Our Ref: 15756
DPE Ref: SSDA 7317 MOD 6

SSD 7317 MODIFICATION 6 - RESPONSE TO REQUEST FOR FURTHER INFORMATION

This letter has been prepared by Ethos Urban on behalf of Mirvac Projects Pty Ltd (Mircvac) to respond to the Request for Further Information issued by the Department of Planning & Environment (the Department) on 16 May 2018 in relation to Modification 6 (MOD 6) to State Significant Development (SSD) 7317.

Figure 2 Revised location of proposed feature stairs at Upper Ground Level

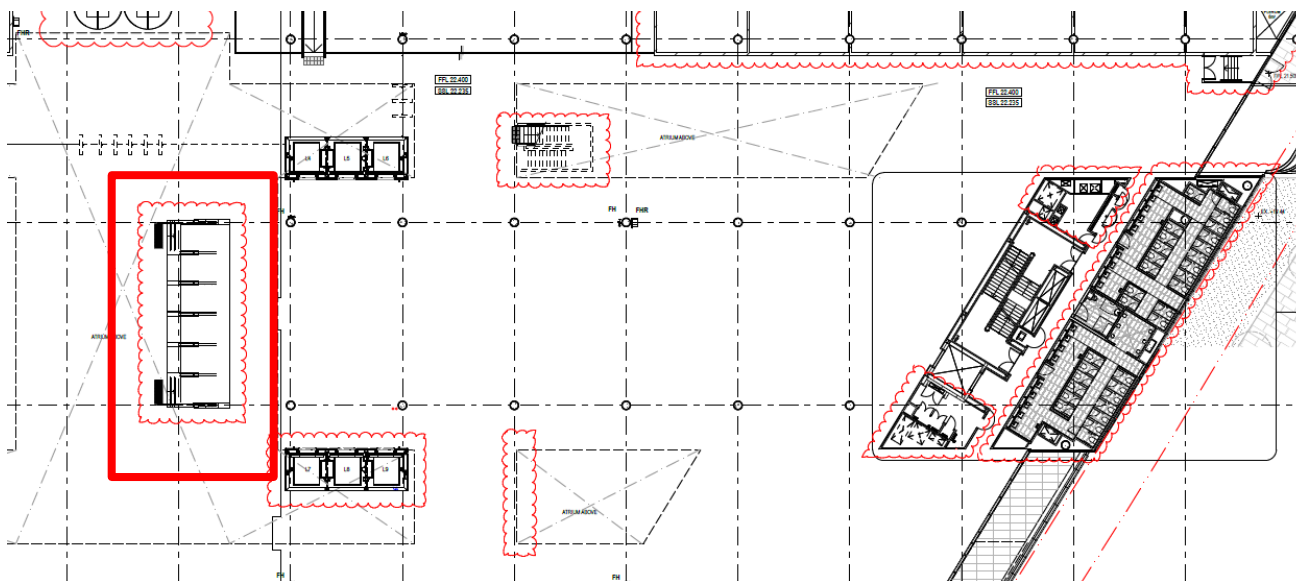
Clarify the new location of the feature stairs on the Upper Ground Floor Level, noting that these are proposed to be relocated.

The amended location and revised design of the feature stairs is shown in the Architectural Plans at the Upper Ground Floor and Level 1 within **Attachment A**. They are also highlighted by a red box in **Figures 1 – 2**.
